"AS BUILT"			
No.	Revision	By	Date
CITY OF ADDISON DALLAS COUNTY, TEXAS QUORUM DRIVE			
<b>OFFSITE DRAINAGE DETAILS</b>			
<b>GINN, INC.</b> Consulting Engineers Dallas, Texas			
DESIGN - GF	DRAWN - GAP	SCALE - AS SHOWN	PROJ. - J-203
APPR'D - WG	CHK'D - GF	DATE - MAY, 1984	SHEET - 32 of 38

**SECTION D**  
(SECONDARY DITCH)

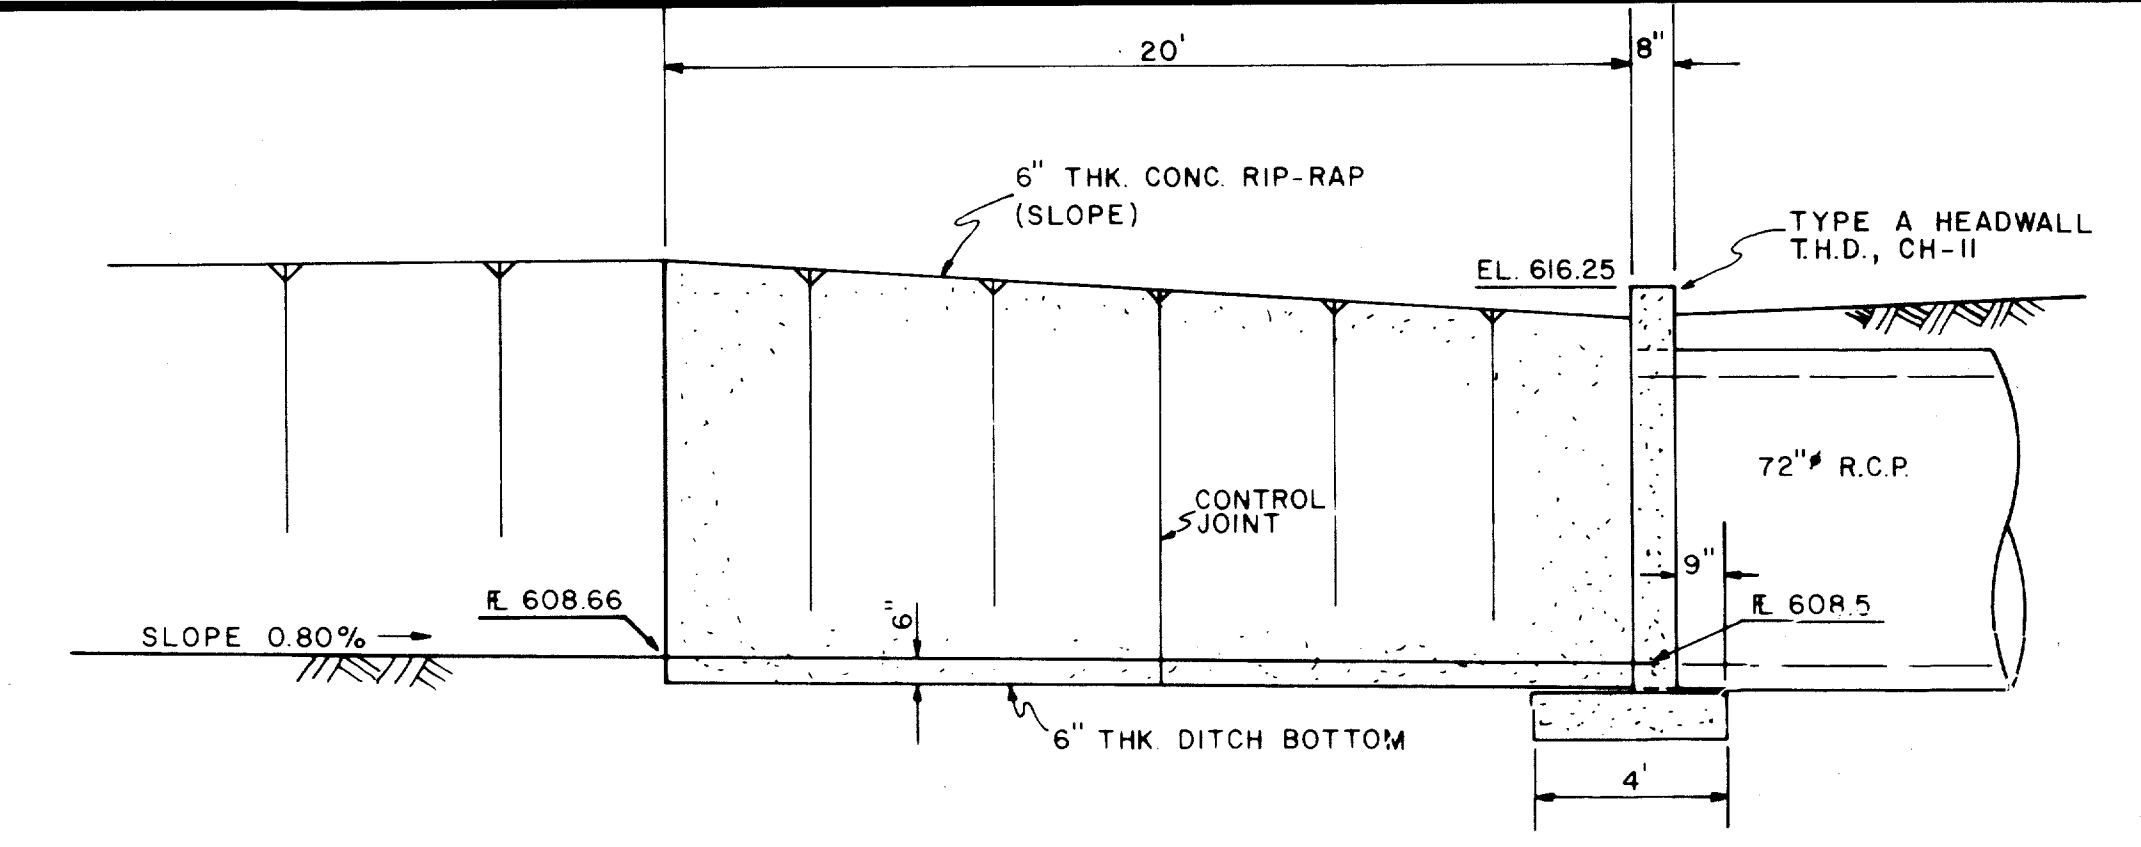
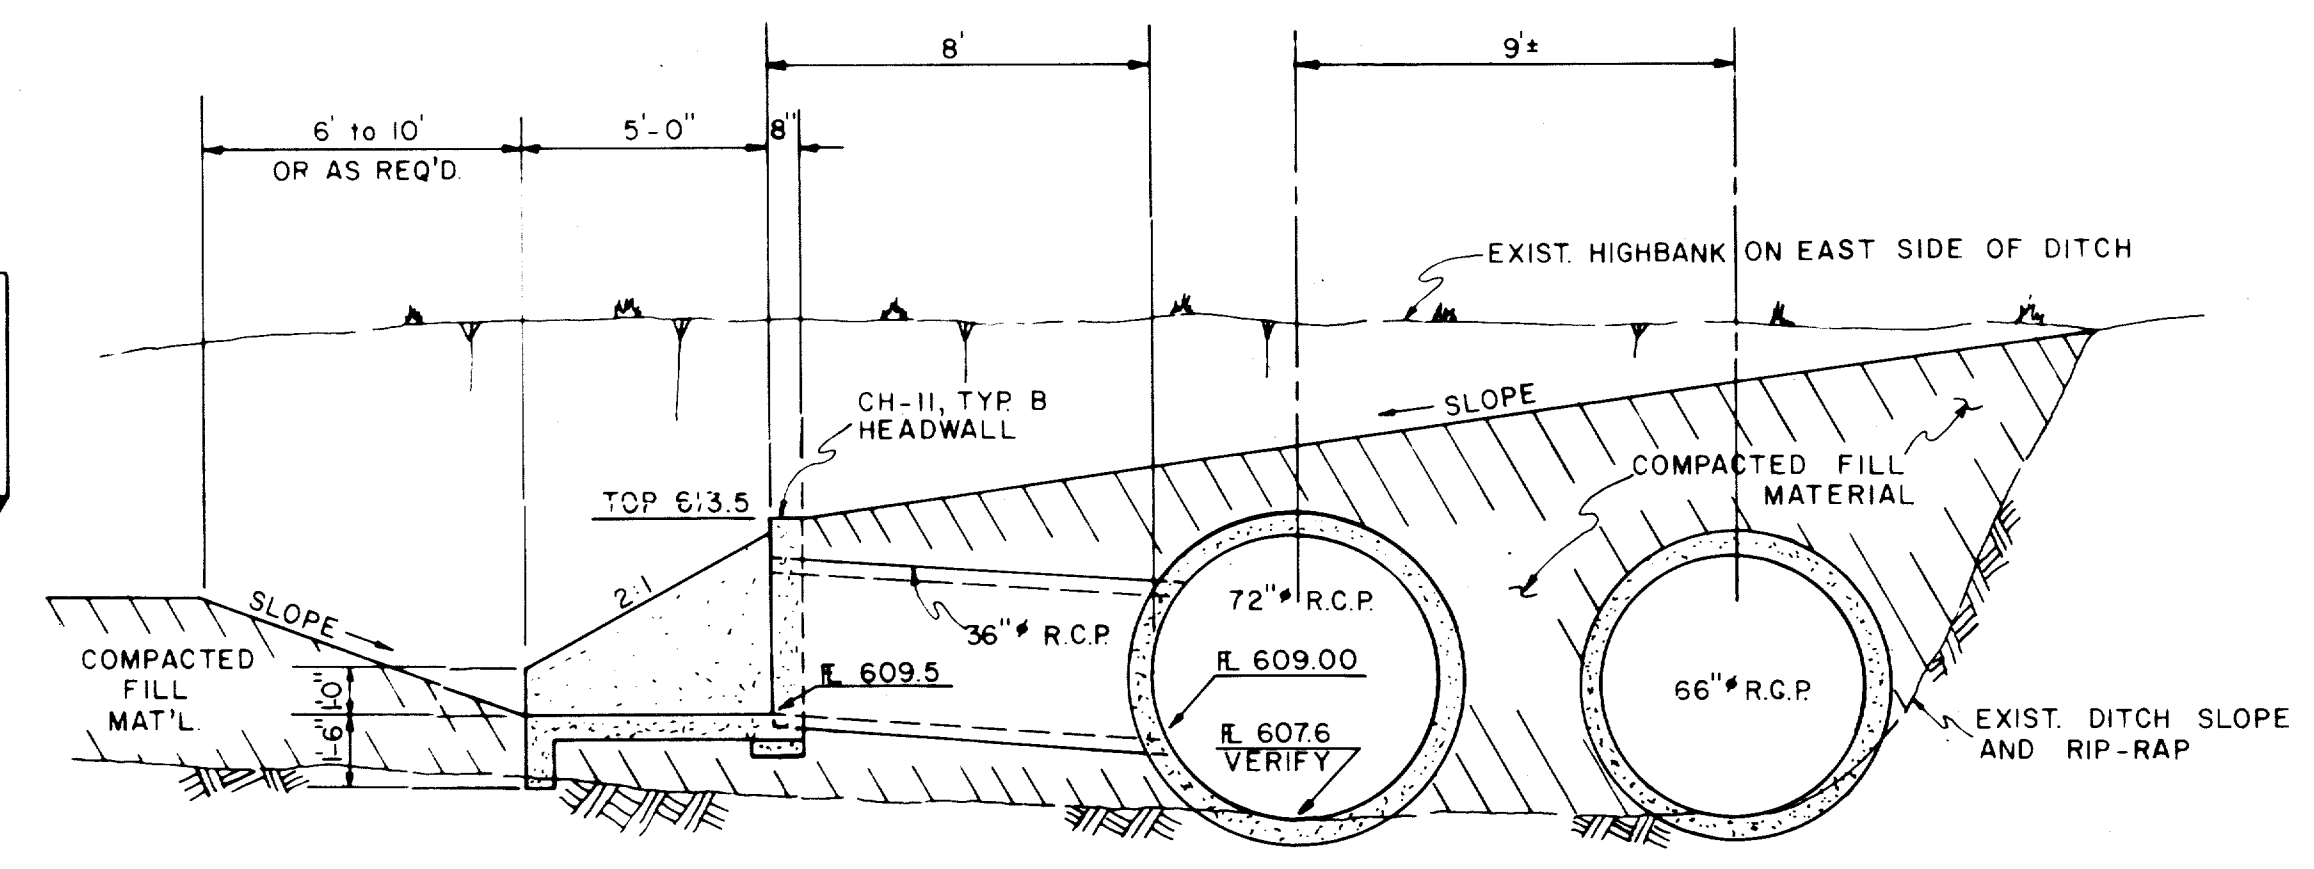
THESE SECTIONS PART OF THIS CONTRACT - ALL OTHER ITEMS SHOWN ON THIS SHEET DELETED BY REVISION Δ.
